TO:	Ron Thompson VanMar Engineering
FROM:	Jeff Williams Program Supervisor, Well & Septic Program
RE:	12031 Scaggsville Road perc test plan
DATE:	April 18, 2019

PERCOLATION TEST PLAN

12031 SCAGGSVILLE ROAD

KNIGHT PROPERTY L. 18591 F. 256 FIFTH ELECTION DISTRICT

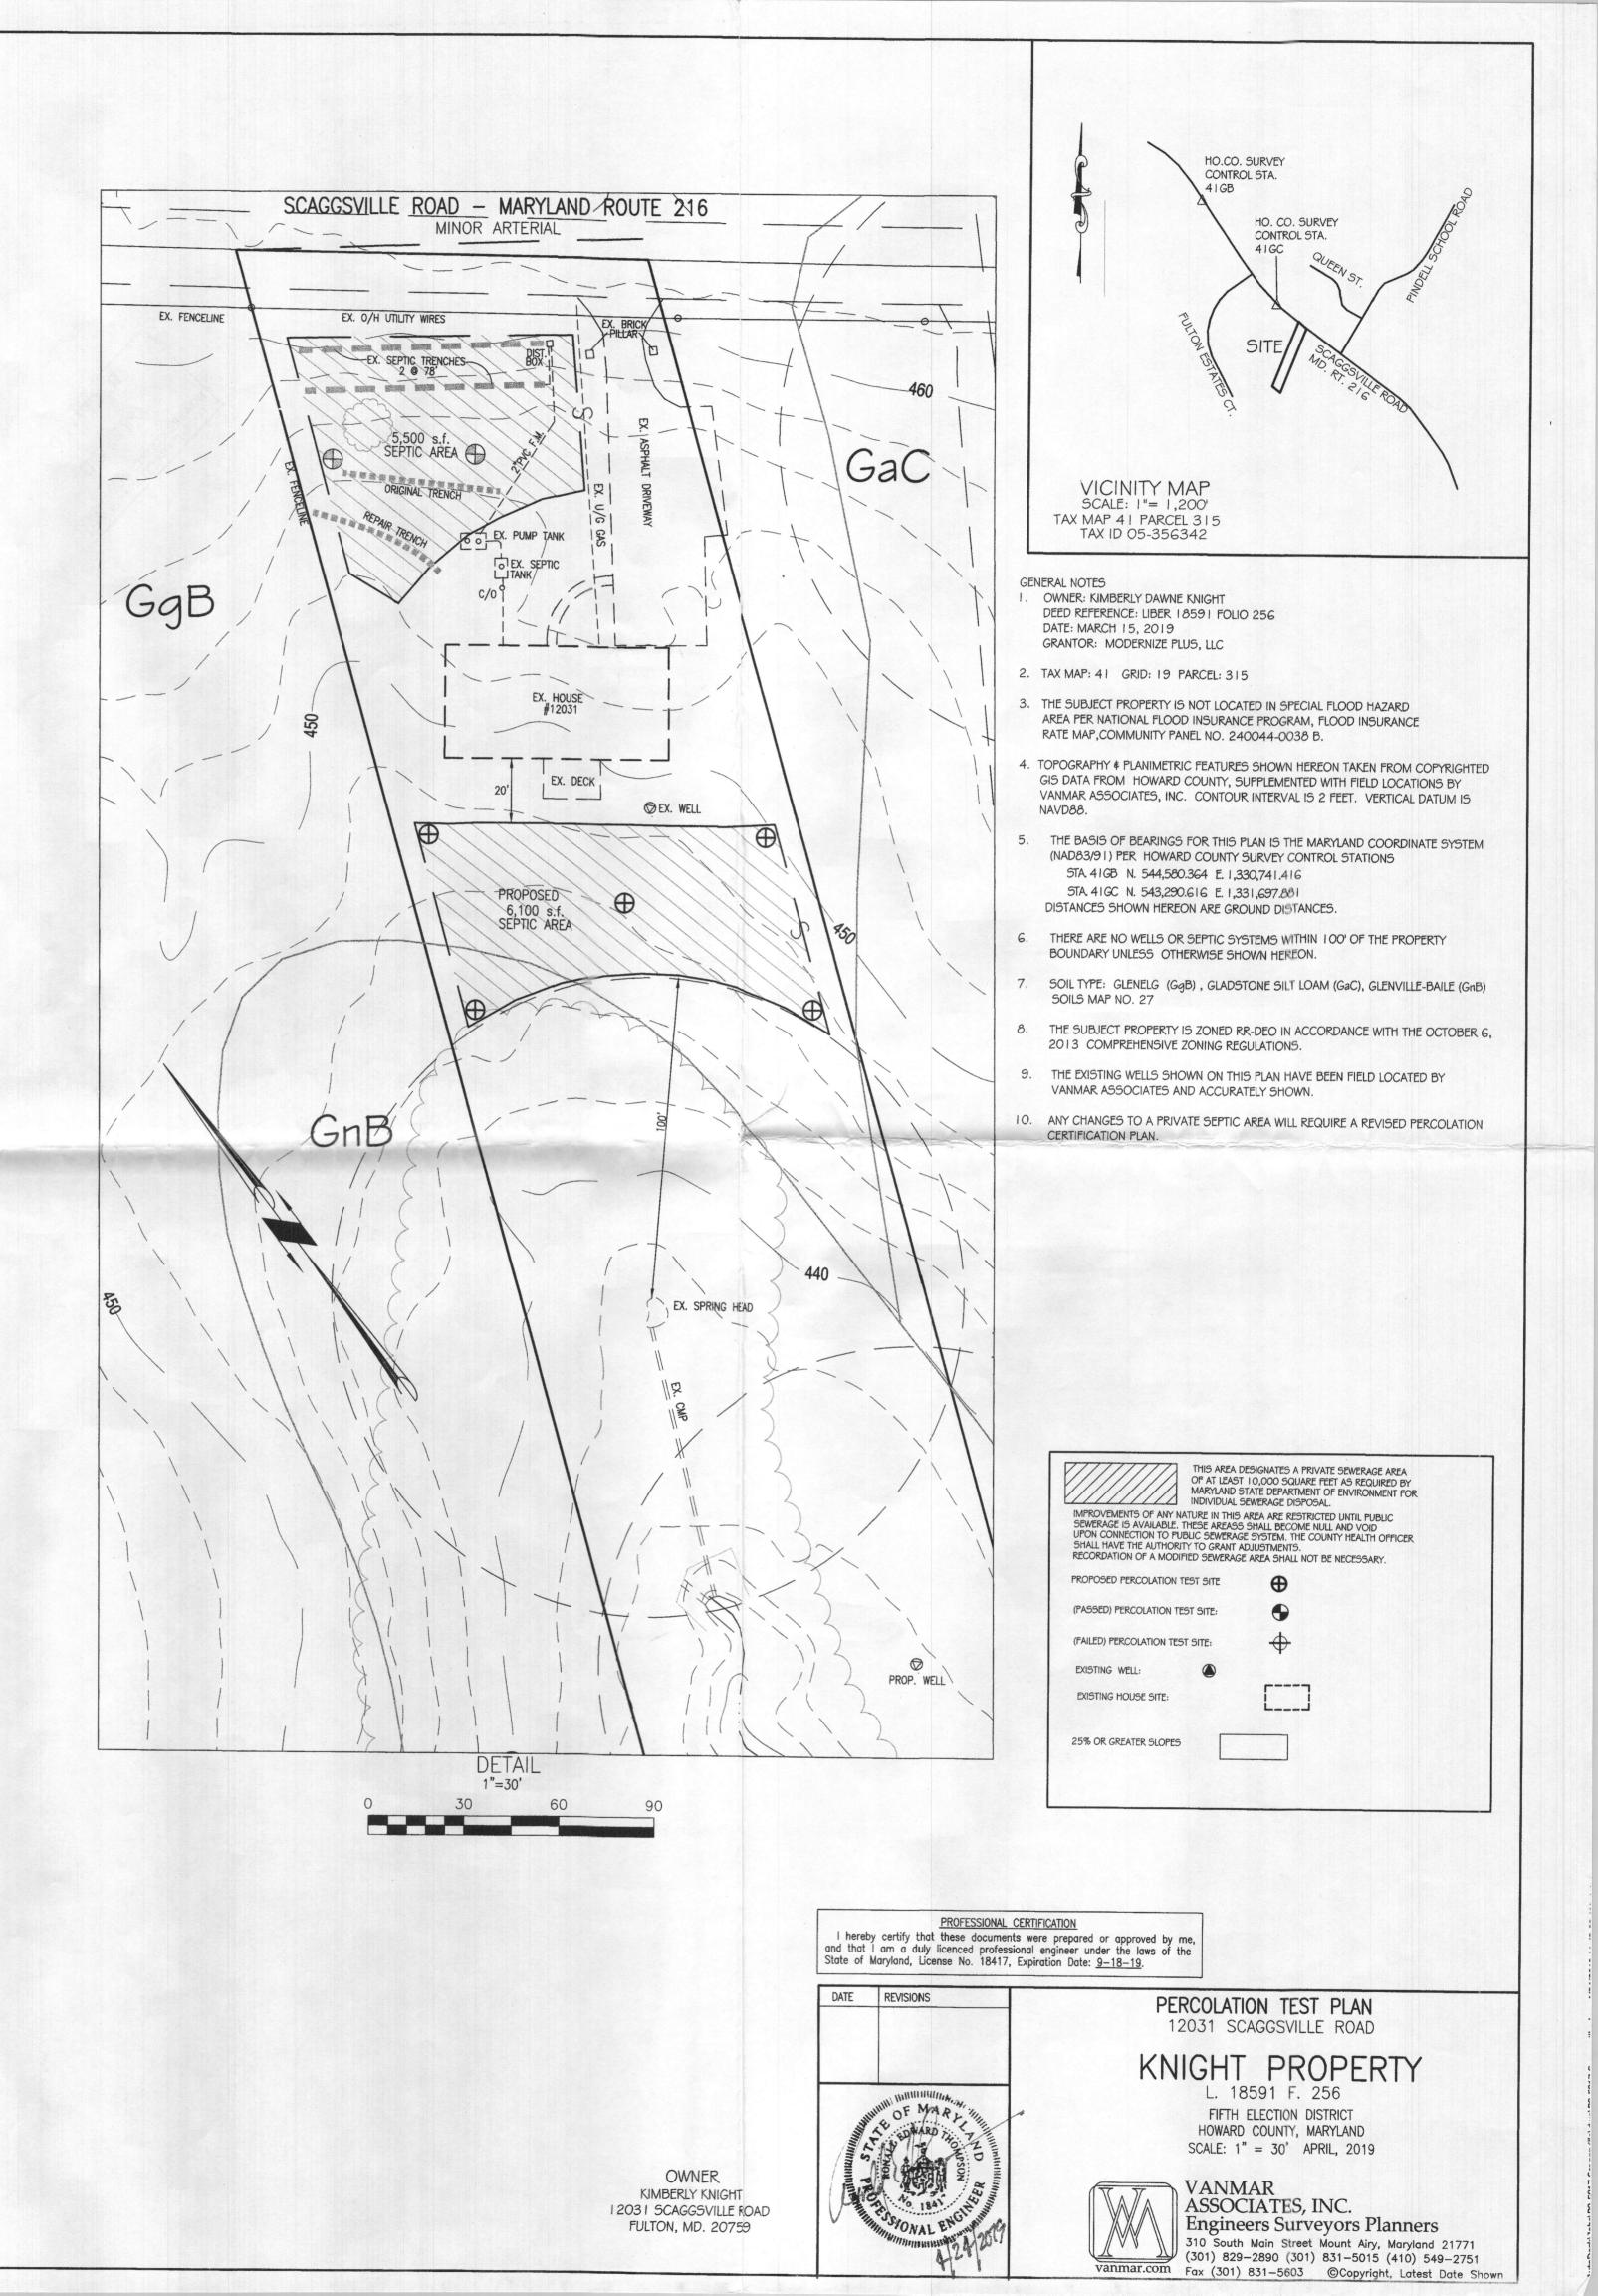
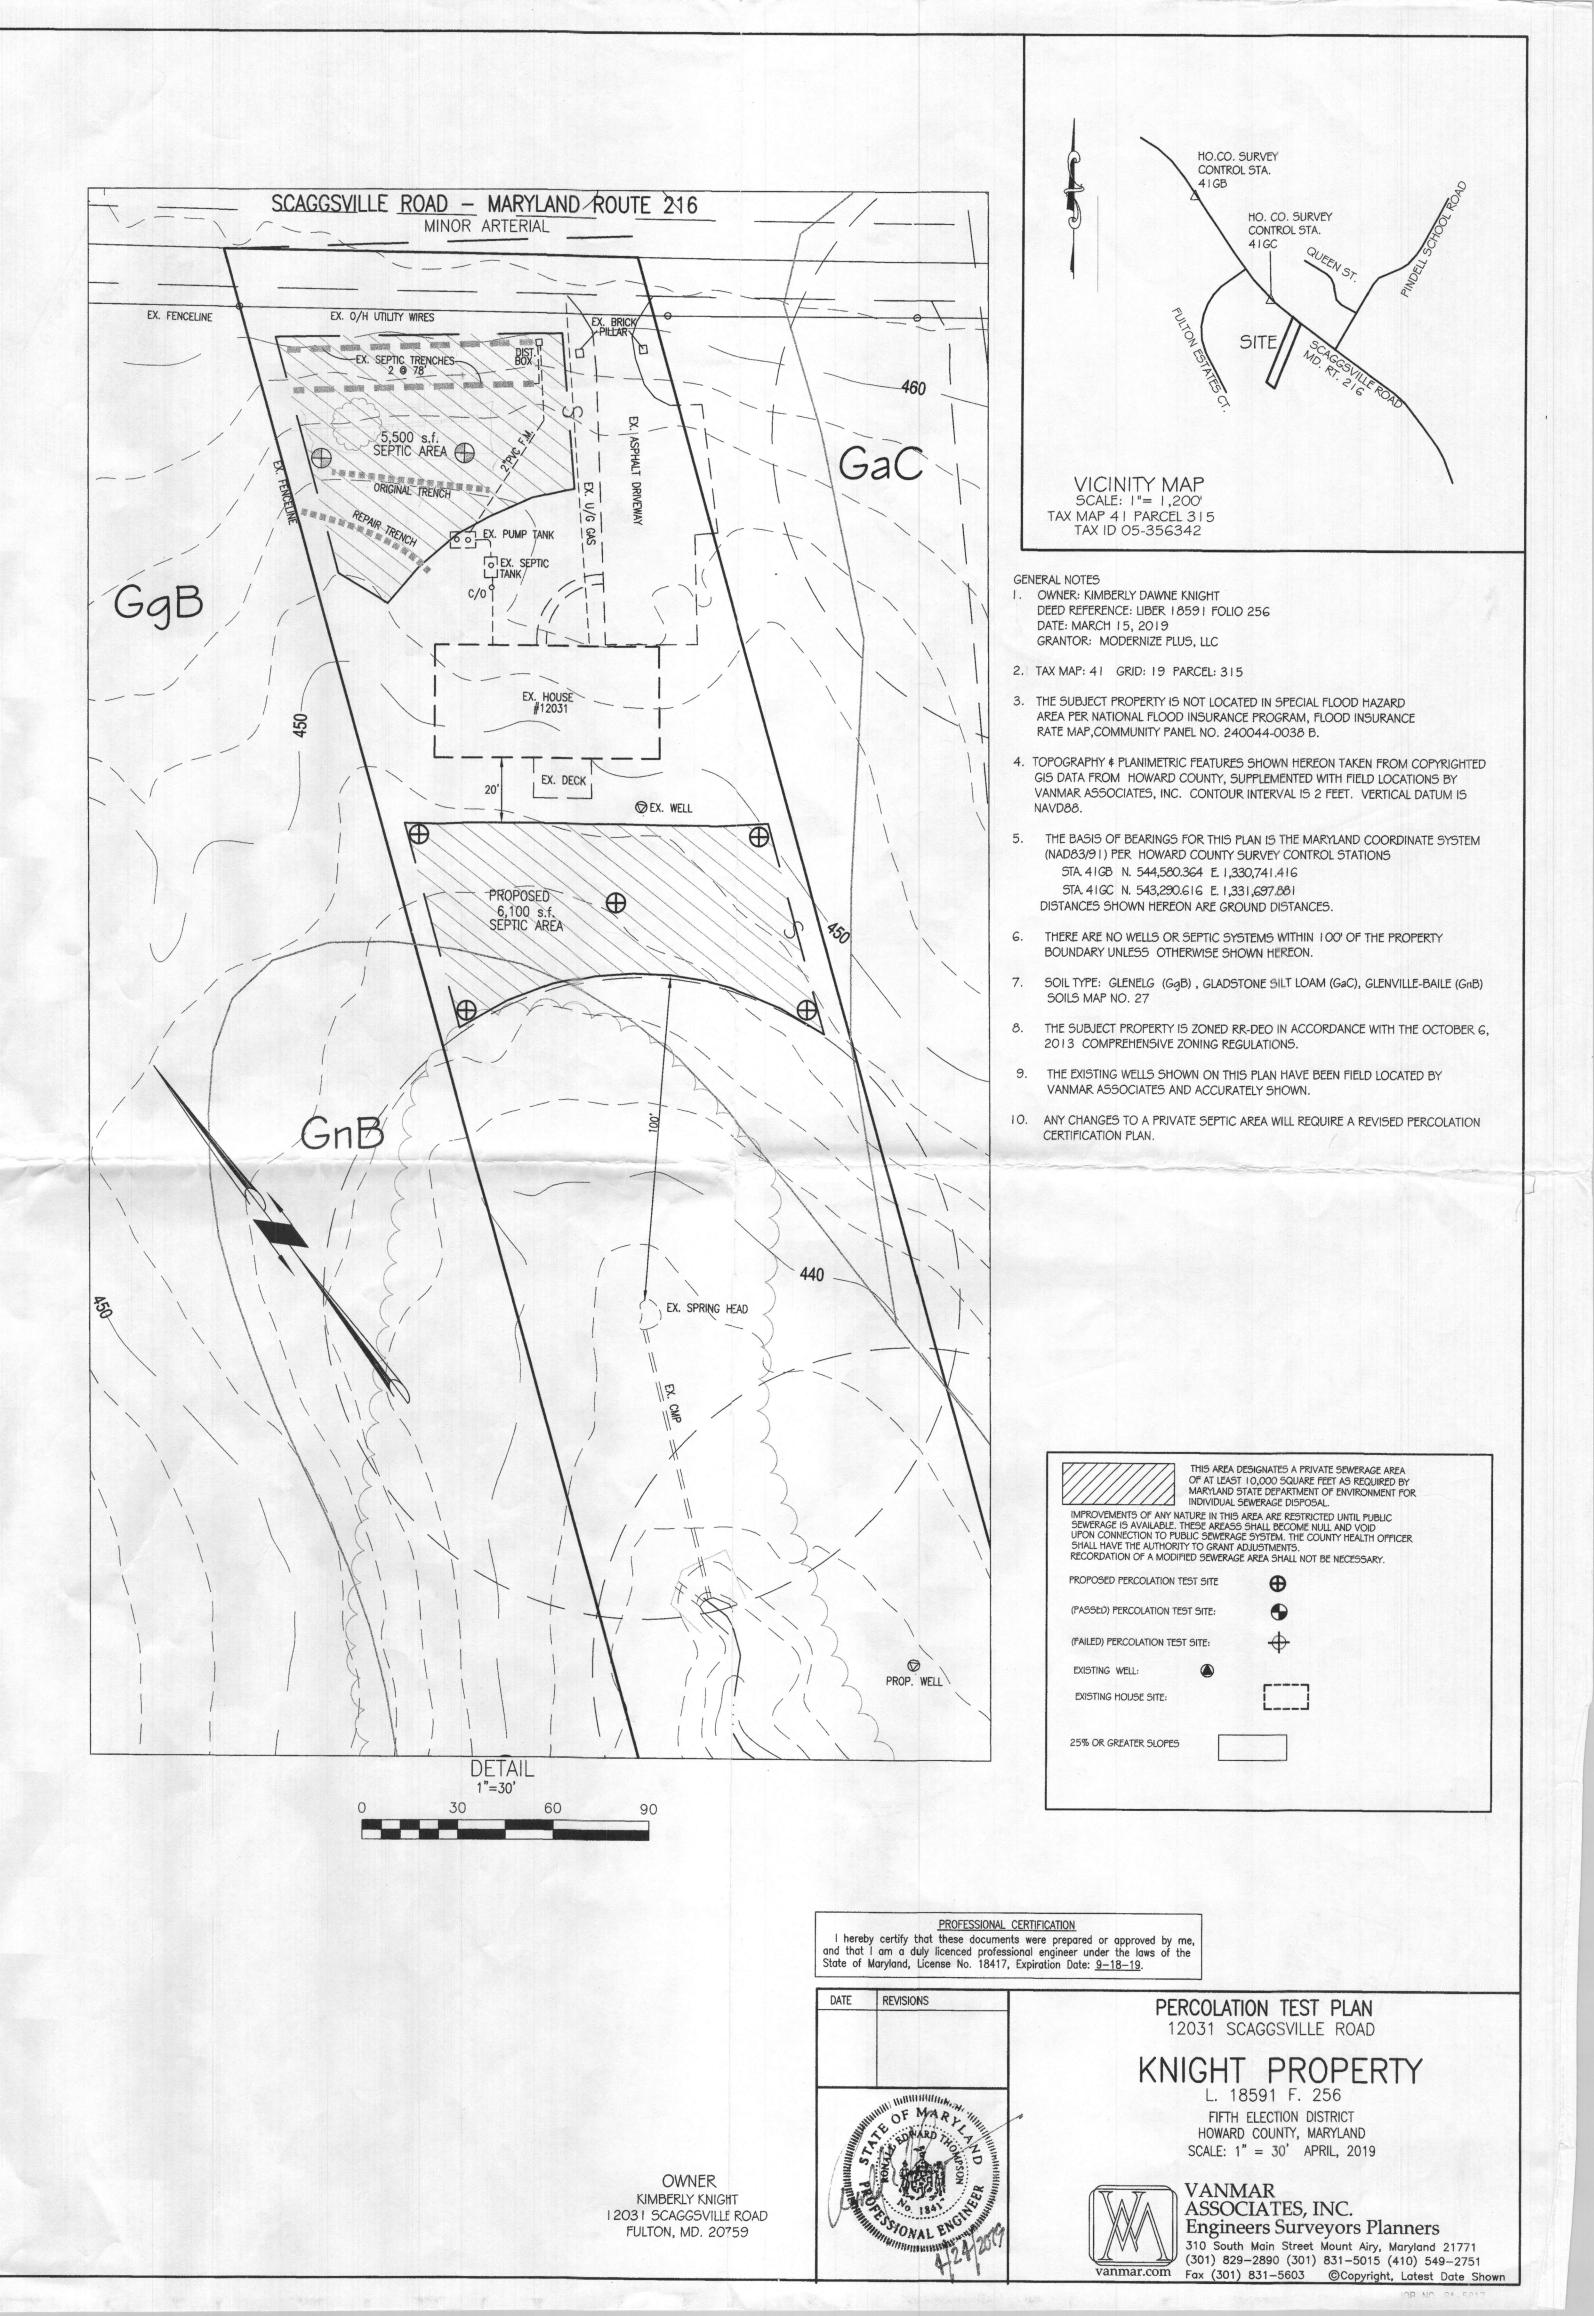
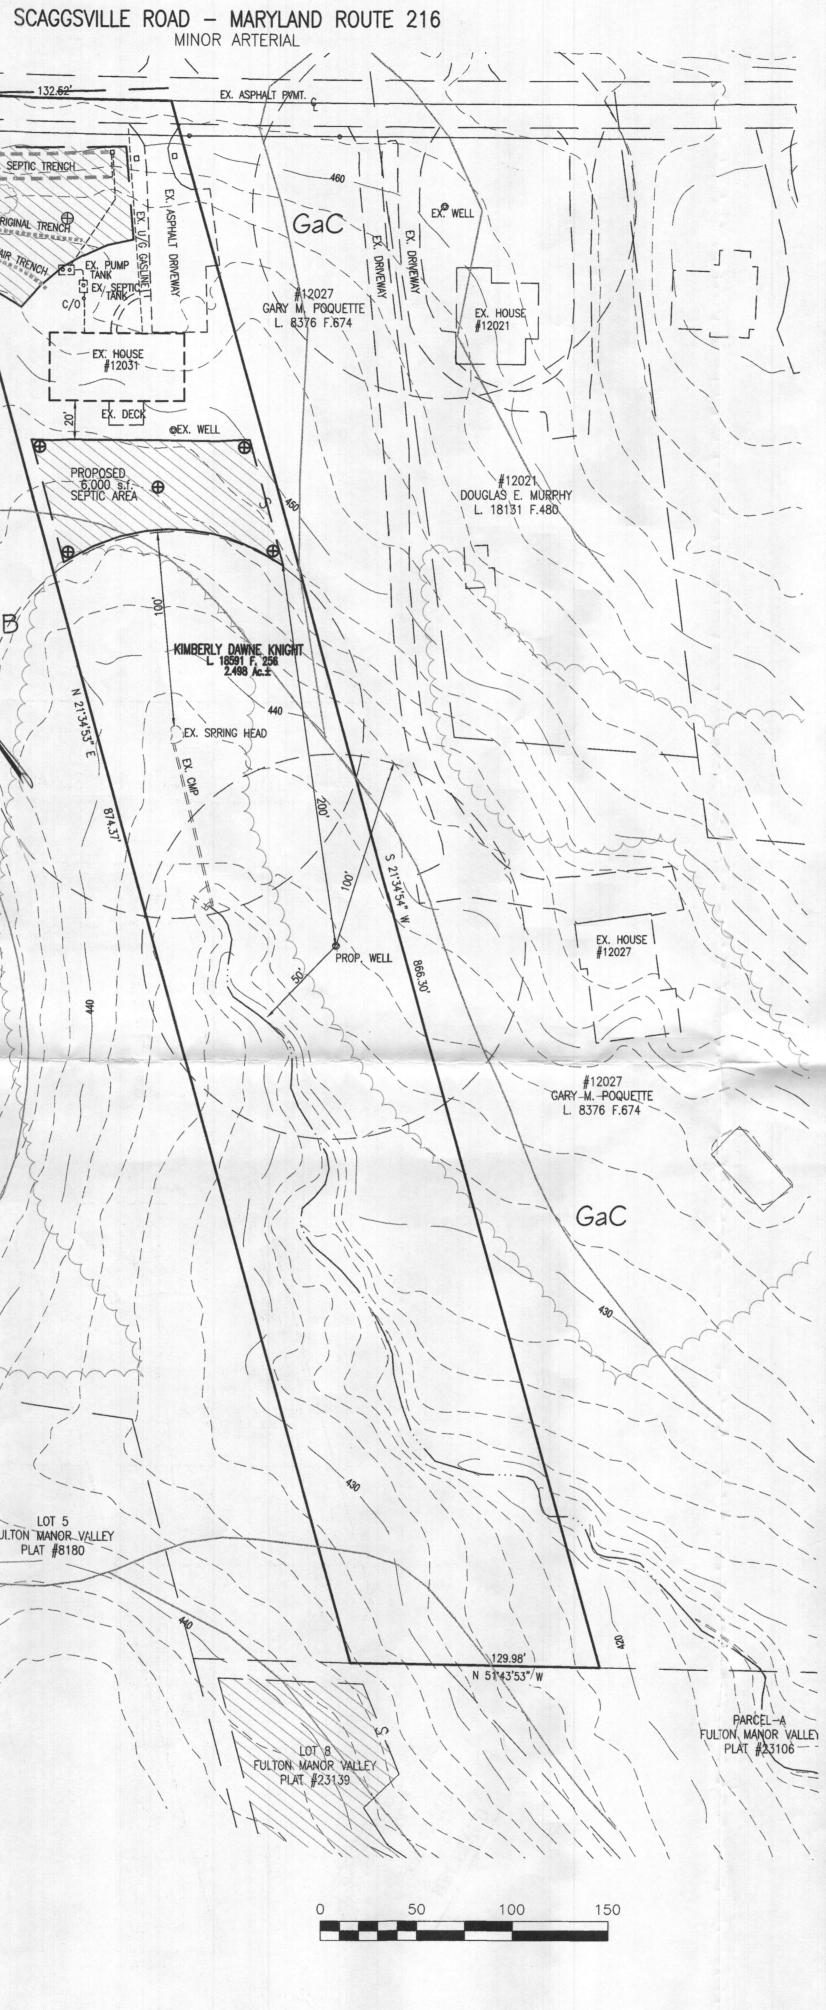
I have reviewed the perc cert submitted electronically on 4/17/2019 and have the following comments:

- 1. The upper test area near the existing trenches is not showing the two older failed drainfields in that area between the new trenches and the house. See the attached health Department file with the repair system as-built diagram from 1981. Once we know where those older systems are located, we can get a better idea of whether there is any room available in the front yard for a future system. We cannot install any future trenches over the old trenches. It is possible that the location of the older trenches eliminates any possibility of fitting a system in the front yard.

- 2. If we are able to test in the front yard, we will not need test holes in the upper corners near the road and the existing trenches.
- 3. Did you field locate the stream in the rear yard? Your plan indicates the stream starting almost 700' from the front property line. However, the perc certification plan for adjacent Fulton Manor Valley (attached) shows it starting around 400' from the front property line. They may not have field located the origin of the stream for that plan, but the Howard County GIS map (attached) shows it starting on the neighboring property 12037 Scaggsville less than 200' from the front property line. Obviously, the stream location will be a major determining factor on where any sewage disposal area can be located in the rear yard as it will need to be at least 100' from the stream. If the stream is located as it is shown on GIS, the majority of the area you show on the test plan is not suitable. A small area near the location of the existing well may be possible, but I'm not sure if it would be large enough to place a system there. Similarly, there is a small area in the rear corner that is outside the 100' setback, but it is so small it does not seem to be useful.

Hi Ron. I'm wondering what your field people discovered with the stream. Dana will be handling this perc if we get to that point. Looking at the test plan, If the stream does start down lower, we will likely look to shift some test holes up into the well arc. The holes on the lower left side do not establish an area suitable for sewage disposal with the swale starting on the 440 and 438 contours. We would look to be more on the south side (right side) of that feature.

Ron, did you field locate the old trench locations? It doesn't look like there is room to fit a replacement system between where you are showing the original trench and the new trenches. If the original trench is any closer, then it would be even worse. We have a perc hole from the repair right in that space downhill from the new trench. We would need two holes on either side down closer to the tank if we were going to pursue that area, but not until we know there is even room to do anything in there.

Did you field locate the start of that stream relative to the rear yard test area?

Jeff: Attached is the updated Percolation Test Plan. The survey field crew will be locating the septic areas, test pits and beginning of the stream today.
